ITEM	SECTION	SUMMARY	PROPONENT	ACTION
IRC-2024-01	PREFACE Part IV Chapter 11	Part IV, Energy Conservation (Chapter 11) is deleted from the INTERNATIONAL RESIDENTIAL CODE FOR ONE- AND TWO-FAMILY DWELLINGS. Substitute all references to Chapter 11 ENERGY EFFICIENCY with references to the <i>Georgia State Minimum Standard Energy Code (International Energy Conservation Code with Georgia State Supplements and Amendments)</i> . James Martin made a motion to carry forward with Chuck Wooley as second. Motion passed unanimously.	2020 amendments	CF
IRC-2024-02	PREFACE Part VII	Part VII, Plumbing (Chapters 25 through 33), is deleted from the INTERNATIONAL RESIDENTIAL CODE FOR ONE- AND TWO-FAMILY DWELLINGS. Substitute for plumbing requirements the <i>Georgia State Minimum Standard Plumbing Code (International Plumbing Code with Georgia State Amendments)</i> . James Martin made a motion to carry forward with James Brooker as second. Motion passed unanimously.	2020 amendments	CF

*Note: These amendments are “proposed only” and have not been adopted by the Department of Community Affairs.

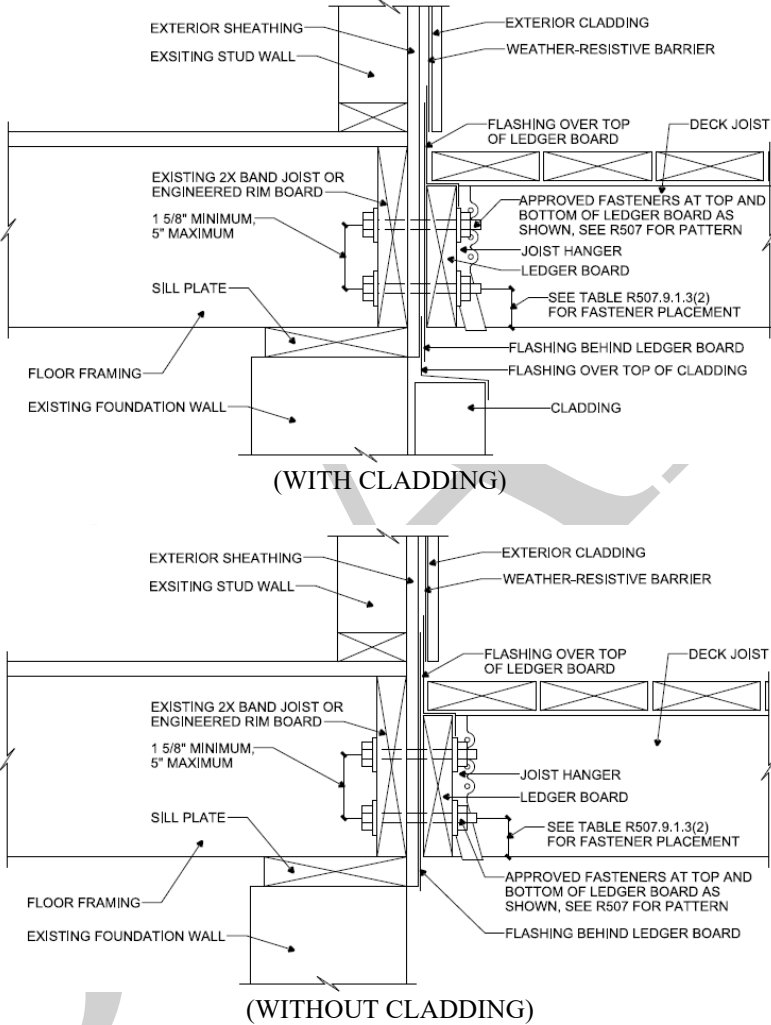
IRC-2024-27	R306.1.9	<p>Delete Section R306.1.9 ‘Manufactured homes.’ without substitution.</p> <p>Alan Cannon made a motion to approve as revised with James Brooker as second. Motion passed unanimously.</p>	2020 amendments	R
IRC-2024-28	R502.6	<p>Revise Section R502.6 ‘Bearing’ to read as follows:</p> <p>R502.6 Bearing. The ends of each joist, beam or girder shall have not less than 11/2 inches (38 mm) of bearing on wood or metal, have not less than 3 inches of bearing (76 mm) on masonry or concrete or be supported by <i>approved</i> joist hangers. Alternatively, the ends of joists shall be supported on a 1-inch by 4-inch (25 mm by 102 mm) ribbon strip and shall be nailed to the adjacent stud. The bearing on masonry or concrete shall be direct, or a sill plate of 2-inch minimum (51mm) nominal thickness shall be provided under the joist, beam or girder. The sill plate shall provide a minimum nominal bearing area of 48 square inches (30 865 mm²).</p> <p>Alan Cannon made a motion to carry forward with Derrick Daniel as second. Motion passed unanimously.</p>	2020 amendments	CF

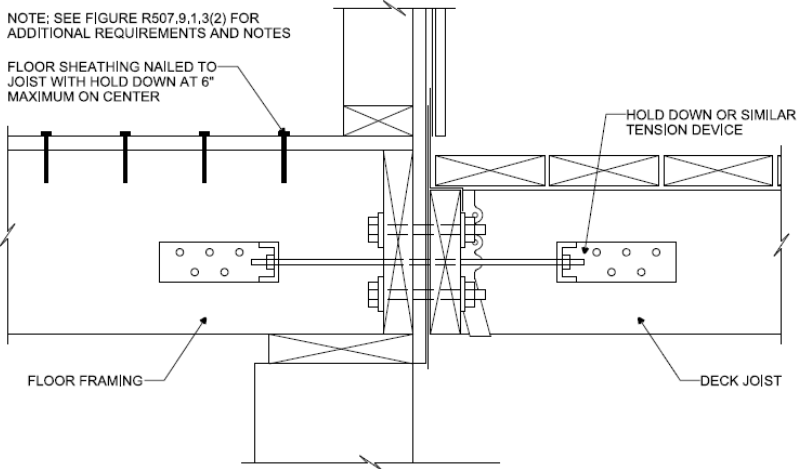
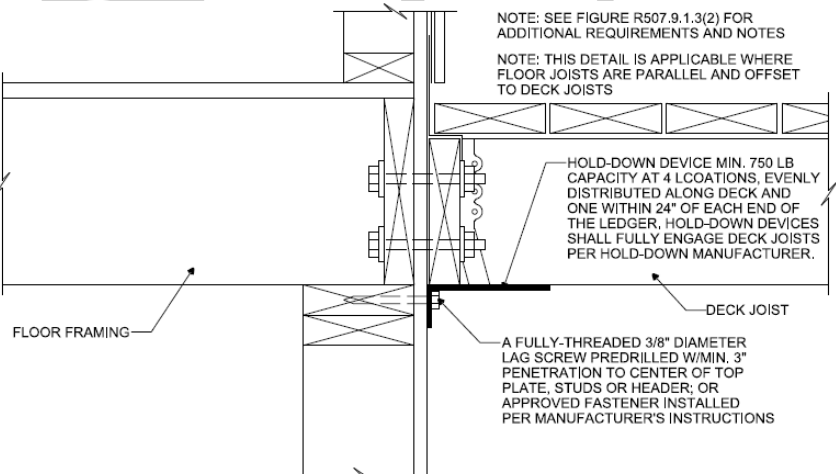
ITEM	SECTION	SUMMARY	PROPONENT	ACTION
IRC-2024-29	R507.5.2(1)	<p>Revise Figure R507.5.2(1) ‘DECK BEAM TO DECK POST’ to include a new illustration for “Corner Beam Over Post” as follows:</p>  <p style="text-align: center;">CORNER BEAM OVER POST</p> <p>Alan Cannon made a motion to carry forward with Derrick Daniel as second. Motion passed unanimously.</p>	2020 amendments	CF
IRC-2024-30	R507.9.1.3	<p>Revise section R507.9.1.3 ‘Ledger to band joist details’ to read as follows.</p> <p>R507.9.1.3 Ledger to band joist details. Where ledgers are fastened in accordance with Table R507.9.1.3(1), fasteners shall comply with Section R507.2.3 <u>or other approved fasteners</u> and shall be installed in accordance with Table R507.9.1.3(2) and Figures R507.9.1.3(1) and R507.9.1.3(2). Holes for 1/2-inch (12.7 mm) lag screws shall be predrilled with two drill bits so that a hole 1/2 inch (12.7mm) in diameter is drilled through the ledger and sheathing, if present, and a hole 5/16 inch (7.9 mm) to 3/8 inch (9.5mm) in diameter is drilled through the band joist.</p> <p>James Martin made a motion to approve as revised with Chris Keeling as second. Motion passed unanimously.</p>	2020 amendments	R
